UNITED STATES
DEPARTMENT OF THE INTERIOR
BUREAU OF LAND MANAGEMENT

Pursuant to the Notice of Incidents of Noncompliance #18RJ011 BIYA Operators, Inc. respectfully submits the 195 line leak work plan.

Revisions to Operator-Submitted EC Data for Sundry Notice #429918

RE: 195 LINE LEAK WORK PLAN

FIGURE 2

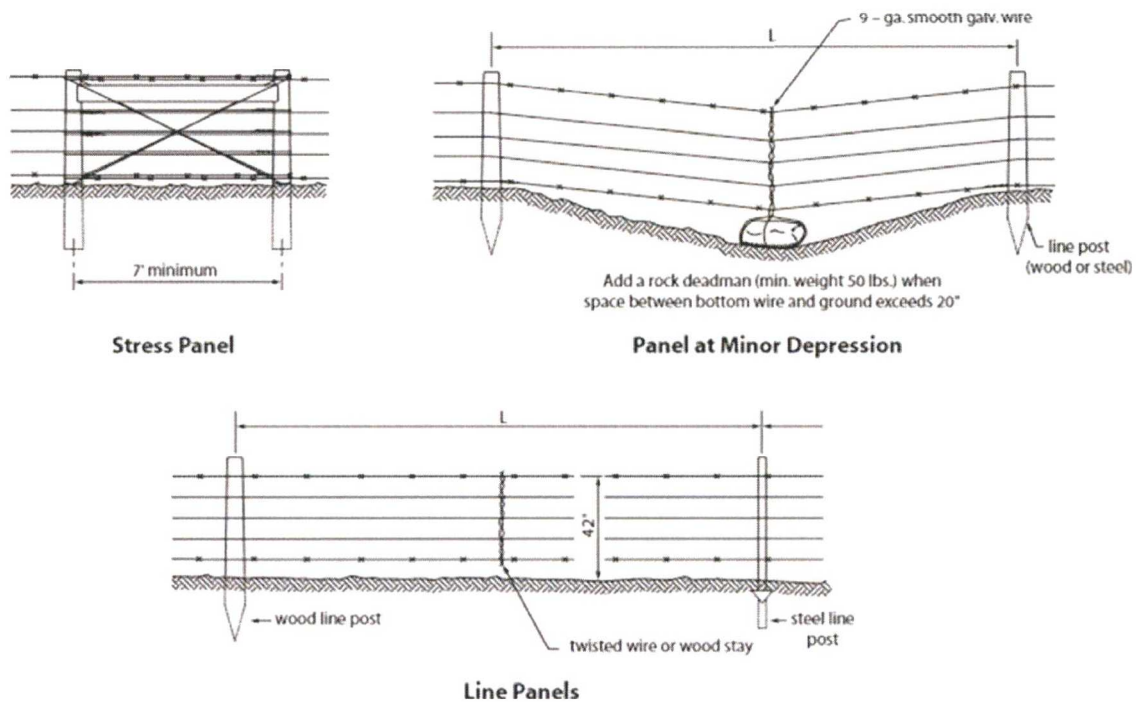
10. (COA) Operator must show evidence of properly capped pipelines. (See IMDA, Exhibit B, Page 3)

12. (COA) Operator must submit documentation of weekly field inspections for integrity of the silt fences to the BLM, UMU tribe, and BIA UMU agency. (Proposed Action Plan, Page 2)

13. (COA) Operator may not stock pile material in or adjacent to Eagle's Nest Arroyo. All material excavated for remedial activities will be contained in a steel container or equivalent device, capable of containing all liquid and solid materials.

14. (COA) Operator will submit a minimum of 5 discrete samples, for each wall, base, or side excavation.
